City of Portland, Maine – Building or Use Permit Application 389 Congress Street, 04101, Tel: (207) 874-8703, FAX: 874-8716

BUILDING PERMIT REPORT

DATE: 22 July 97 ADDRESS: 60 MITTON ST
REASON FOR PERMIT: Rebuild/expand Front Porch
BUILDING OWNER: Mary S Loard
CONTRACTOR: Brian Beaulieu
PERMIT APPLICANT: D. Gailey APPROVAL: *1, *2, *8, *10 ~~DENIED~~

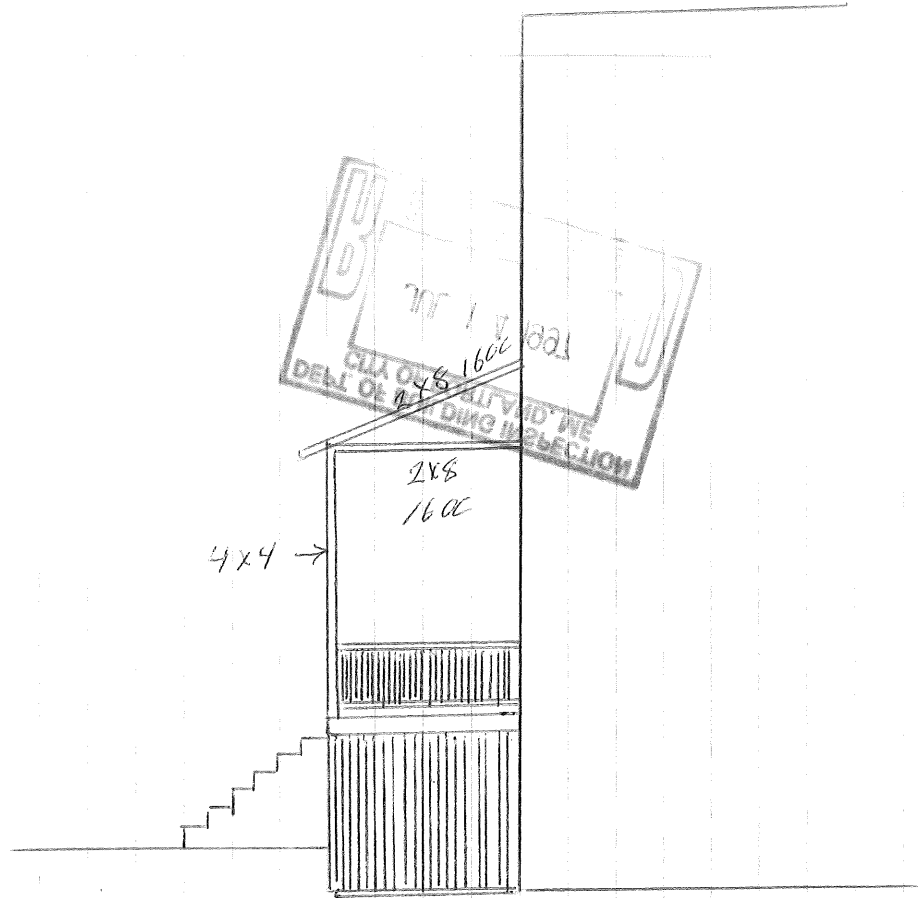
20'
Min front setback req'd
30' shown - OK
